CITY PLANNING COMMISSION

- APPLICATION:**
- A. Ratify Negative Declaration
 - B. Rezone 3 vacant corner lots totaling 0.4 acres from Single Family (R-1) to Townhouse (R-1A) zone (Zoning Ord., Sec. 7)
 - C. Tentative Parcel Map to subdivide 3 existing corner lots into six halfplex lots (Sub. Ord., Chapter 40)
 - D. Special Permit to develop 6 halfplexes (Zoning Ord., Sec. 7)

PROPOSAL: The applicant is requesting the necessary entitlements to develop six halfplex units on three corner lots in the Riverwind Subdivision.

STAFF EVALUATION: The staff has the following comments regarding this application:

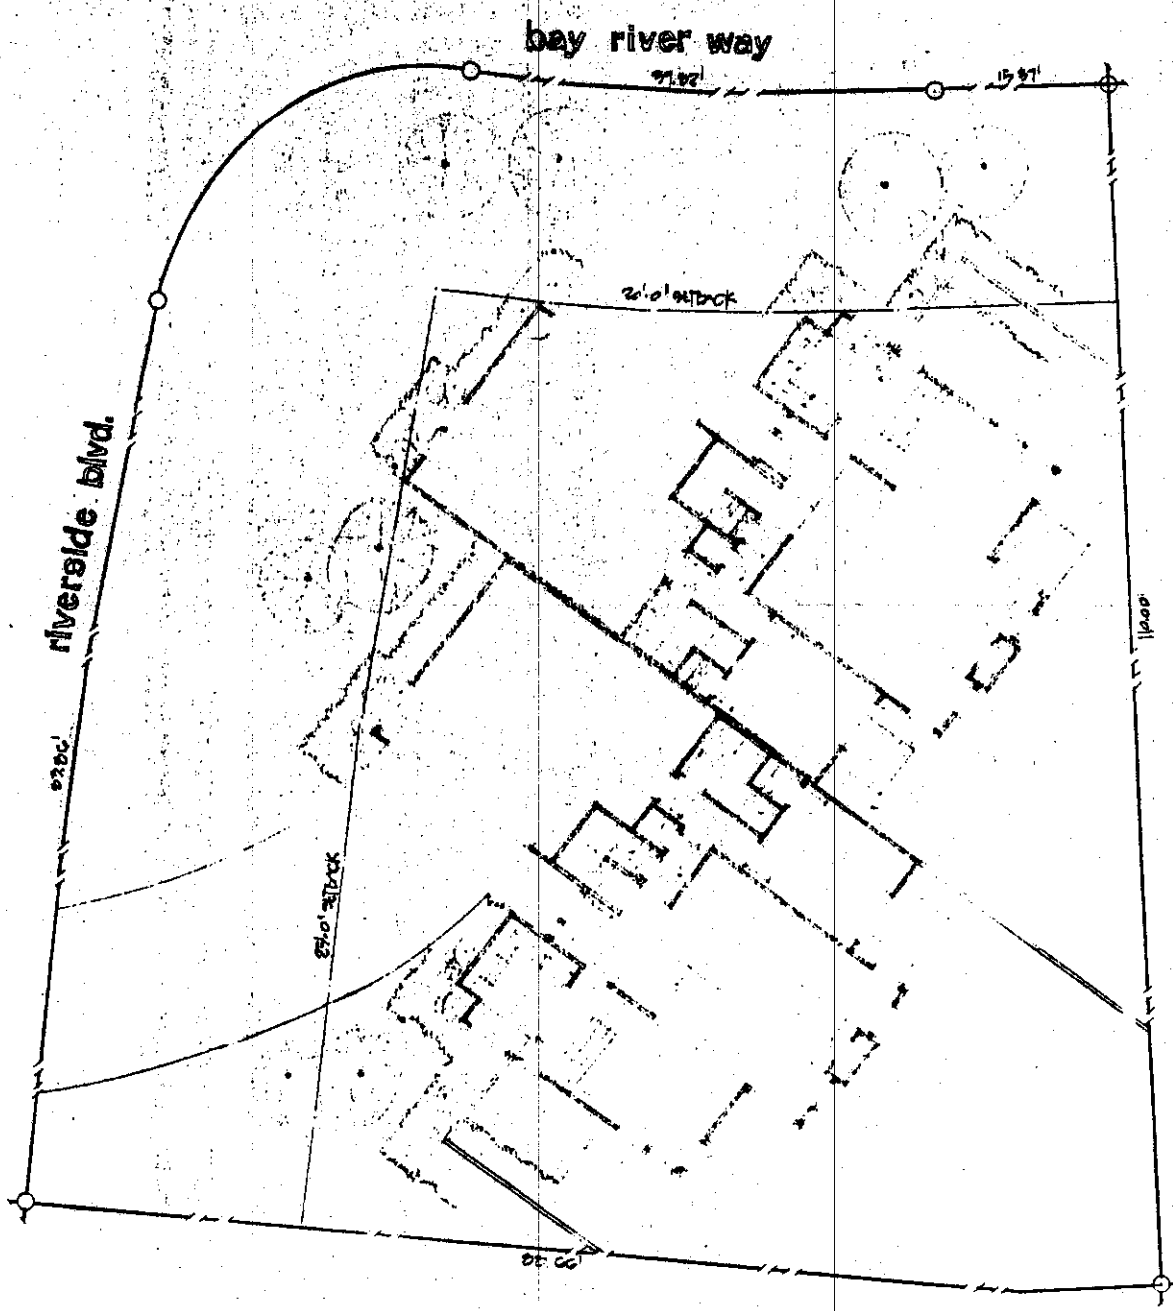
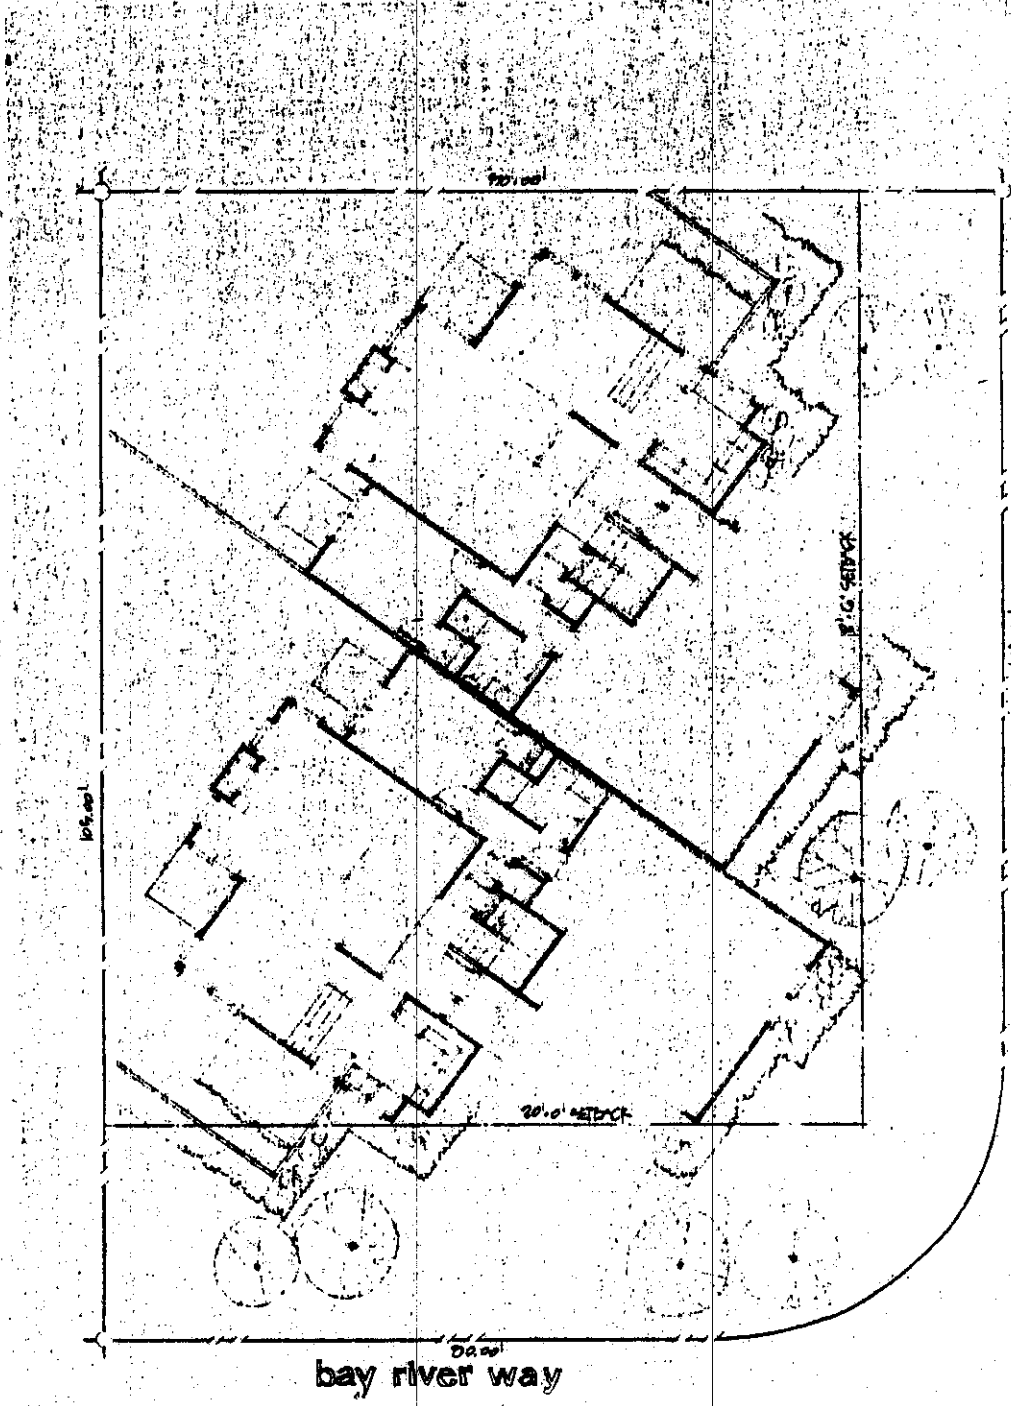
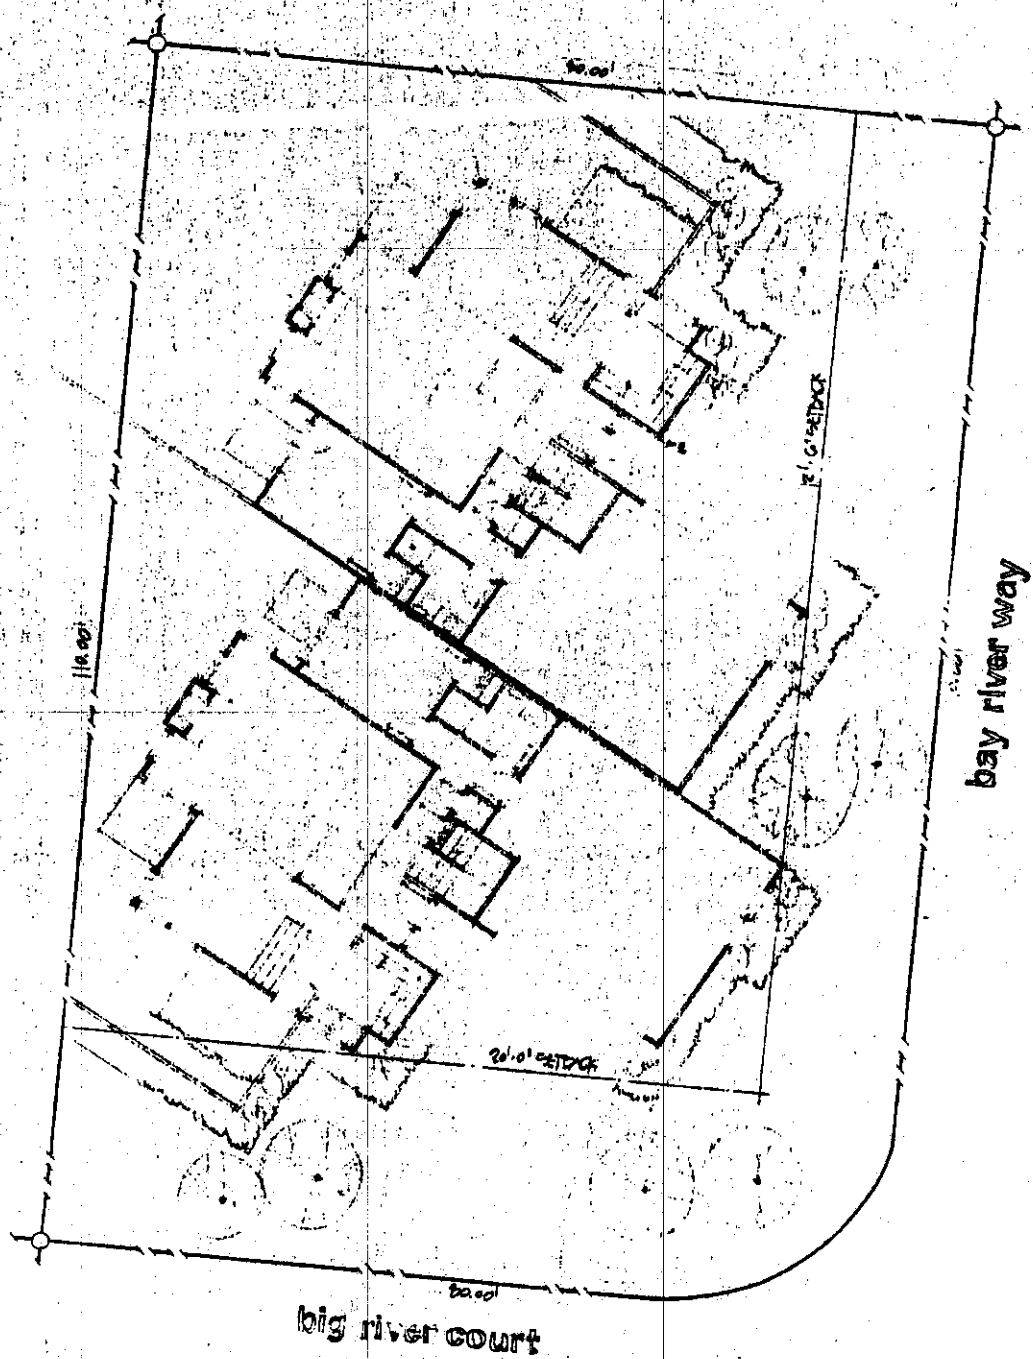
2. The applicant proposes to locate each structure at a diagonal angle on the lot. Under the R-1A zone, which allows flexibility regarding building setbacks, the front yard setback is proposed at 20 feet rather than the standard 25 foot setback under the R-1 zone. The front yard setback for all existing homes adjacent to the three proposed structures is 25 feet. Staff, however, does not necessarily oppose the proposed 20-foot building setback, based upon the design and diagonal placement of the structures on each lot. The front and side elevations of each structure contain many offset planes which tend to present an interesting facade from street view rather than the typical flat plane facade of most typical halfplexes. Due to these offsets and diagonal placement of the structure on the lot, only the corner of the kitchen and corner of the garage project into the standard 25-foot front yard setback area. The remainder of the front building plane is recessed behind the proposed 20-foot front yard setback.

In addition, the front of the garage is located at an angle to each street which reduces the visual impact of a large garage door from the street perspective. From the street corner, one would be viewing the sides of the two garages rather than the garage doors.

All three structures will adhere to the minimum 12½ foot street side yard setback.

The only modifications requested by staff relative to the site plan is that the six-foot high fence proposed to extend beyond the 20-foot front yard setback be held back at the 20-foot setback line, and that all curved driveways turn 90° at the sidewalk and maintain a minimum 20-foot distance between the front of the garage and property line at the closest point.

- 1. The primary exterior building materials of all three structures shall consist of horizontal wood siding and wooden shake roofs.
- 2. The six-foot high patio fence proposed in the front yard setback area shall be set back 20 feet from the front property line.
- 3. The distance of all driveways between the front of the garage and front and street side property lines at the closest points shall be a minimum 20 feet. The curved driveways shall be modified to turn at a 90° angle to the sidewalk.
- 4. Revised plans indicating the above items shall be submitted to staff for review and approval prior to issuance of building permits.

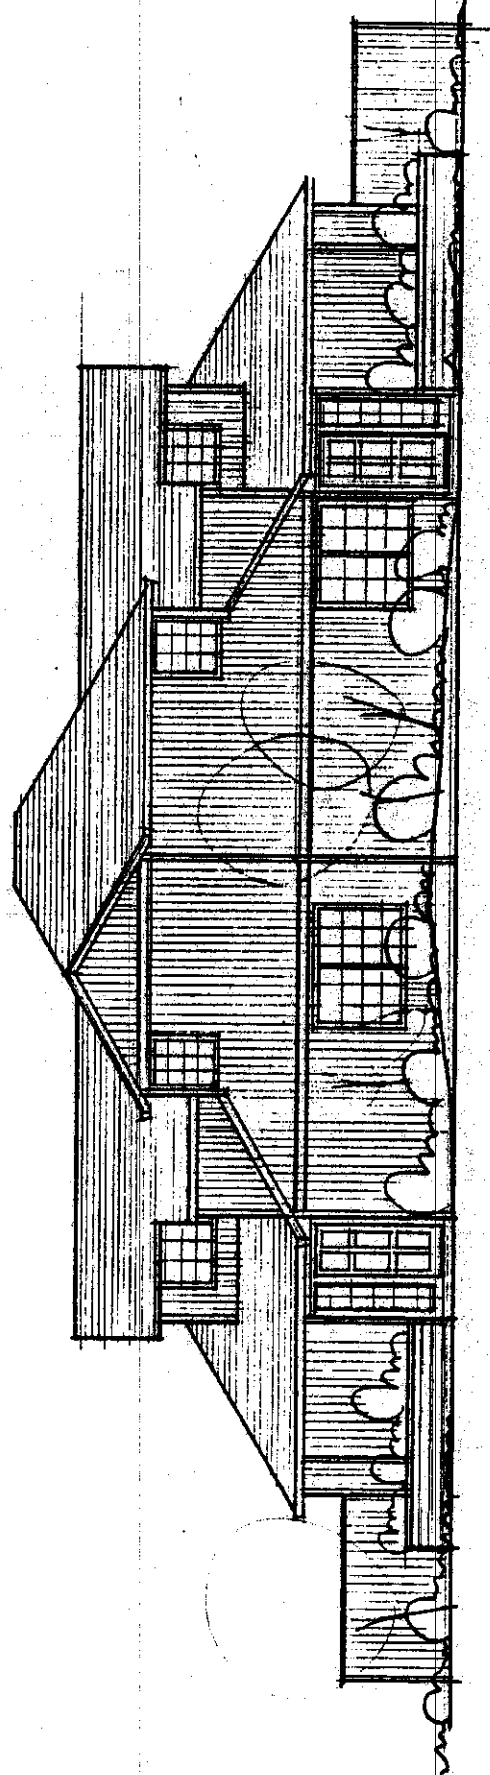
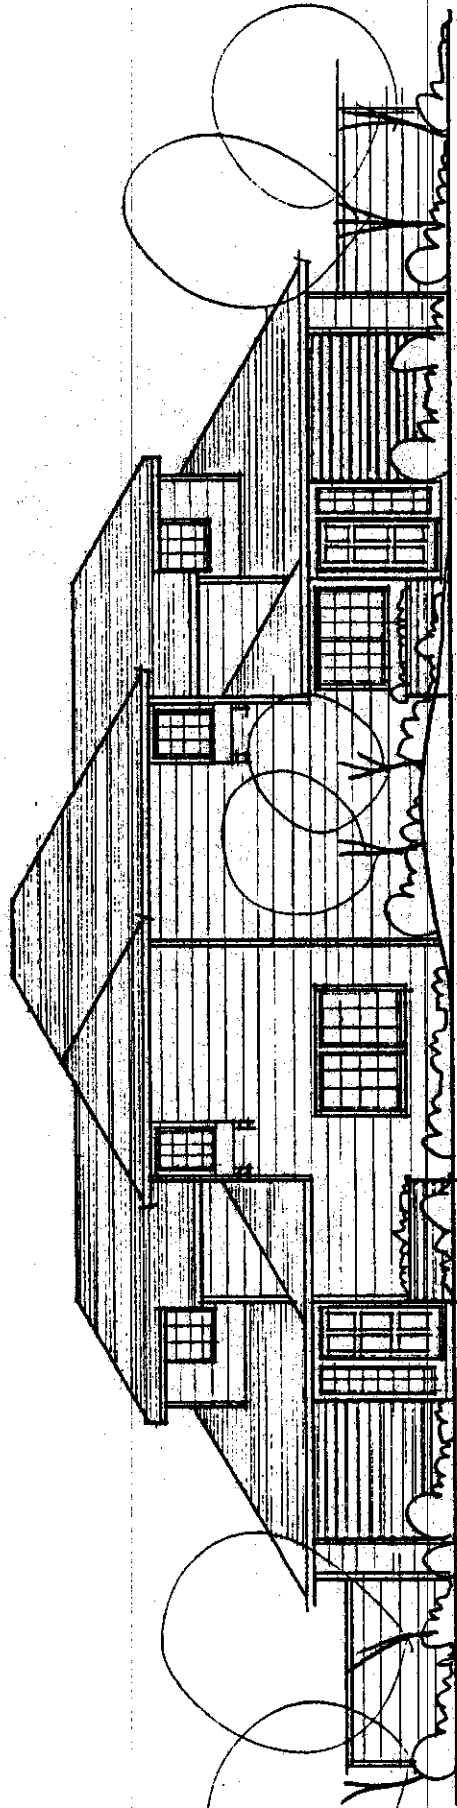
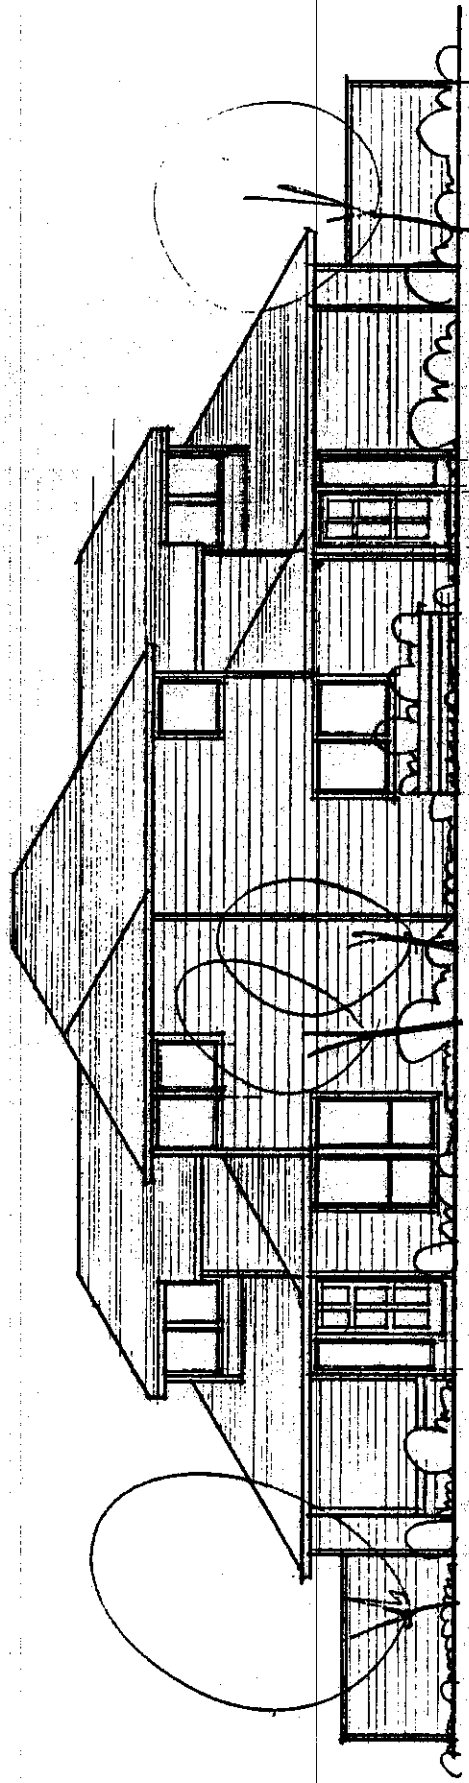
1. The subject sites consist of three corner lots located in the Riverwind subdivision. The applicant proposes to develop two-story halfplex structures on each corner lot. The size of each unit is approximately 1,400 to 1,500 square feet in area. The applicant proposes to use either horizontal wood siding or T-111 plywood siding with wooden shake roofs as the primary exterior building materials. In order to provide a more interesting contrast to the other existing structures in the subdivision, staff requests that all three halfplex structures be constructed of horizontal wood siding with wooden shake roofs.
